Project  
Springfield Farm, Kingston Bagpuize

**PARISH/TOWN COUNCIL RESPONSE FORM**

Application Number P16/V0234/O

Address of Proposal Springfield Farm Bullockspit Lane (Kingston Bagpuize with Southmoor) Longworth OX13 5HJ

Title  
Proposed Parameter Plan Combined

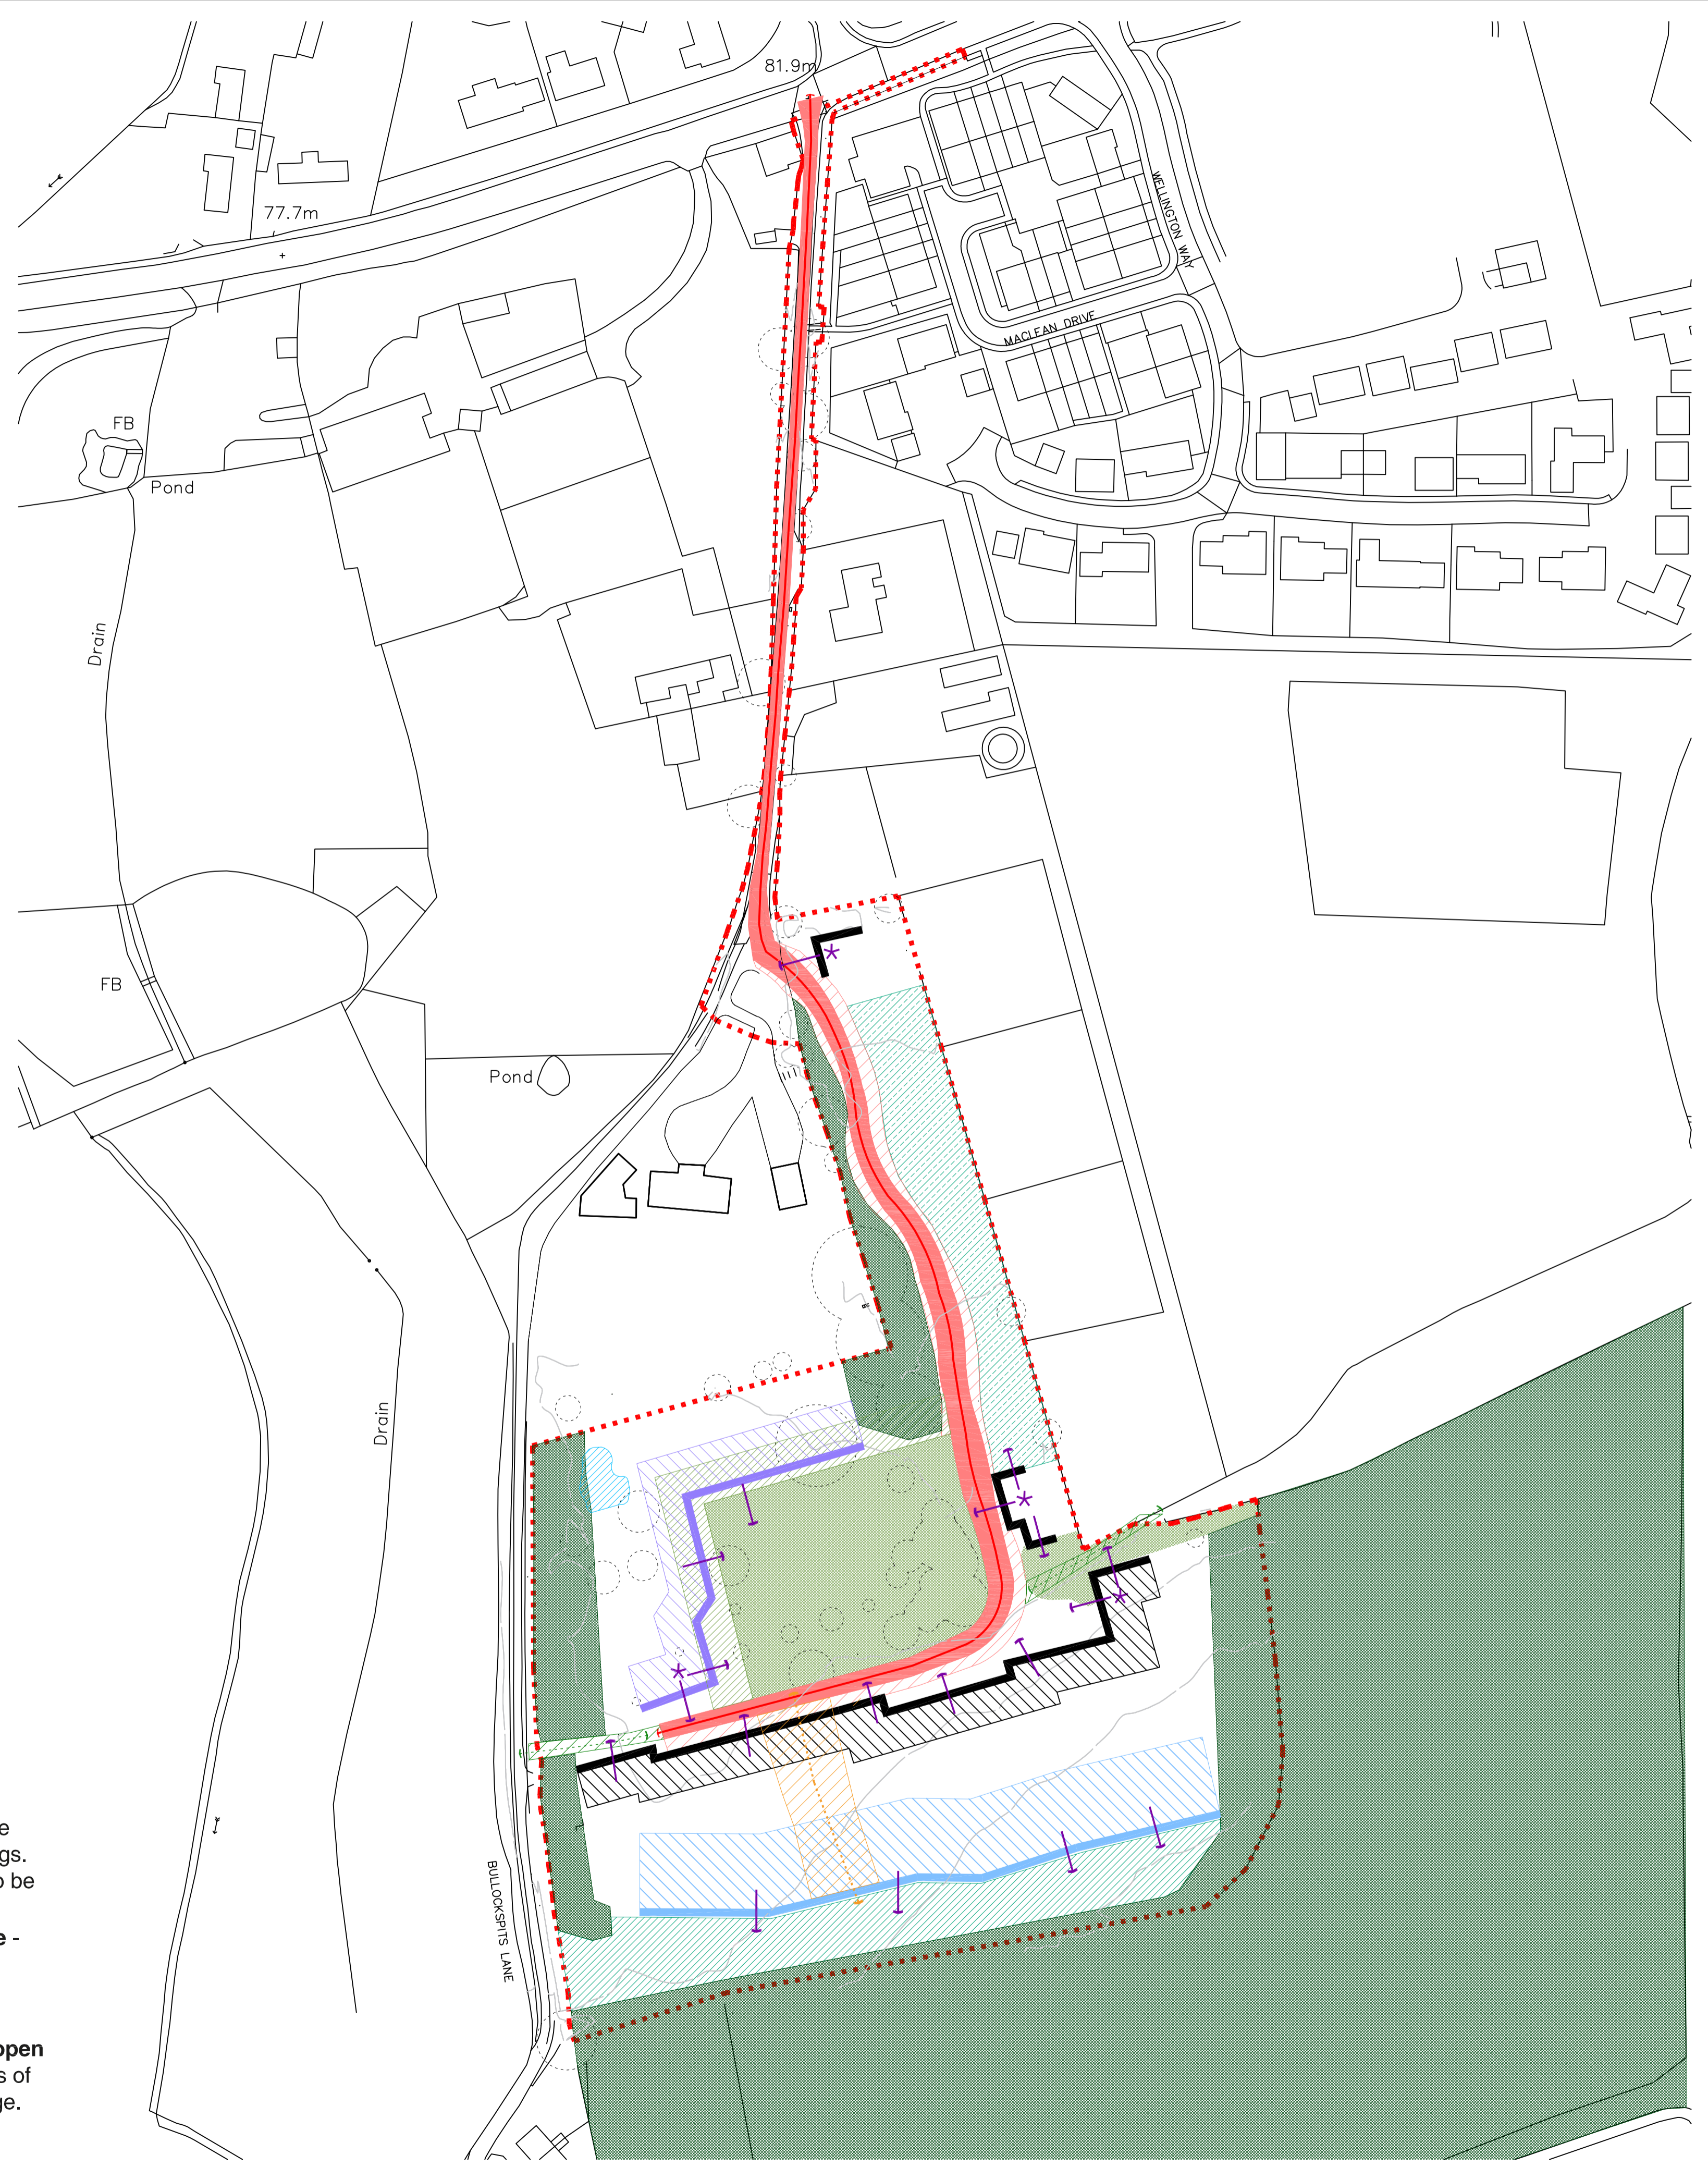
ACCESS ROAD POSITION  
ADJUSTED TO CREATE  
ADDITIONAL SPACE TO UNITS

LOSS OF 1NO.  
CAT. C TREE

SWALE RELOCATED  
FURTHER SOUTH TO  
REDUCE IMPACT OF  
PROPOSED DEVELOPMENT  
ON THE CAT. B TREES

LOSS OF 2NO. CAT. C  
TREES FOR ACCESS  
ROAD OPTION
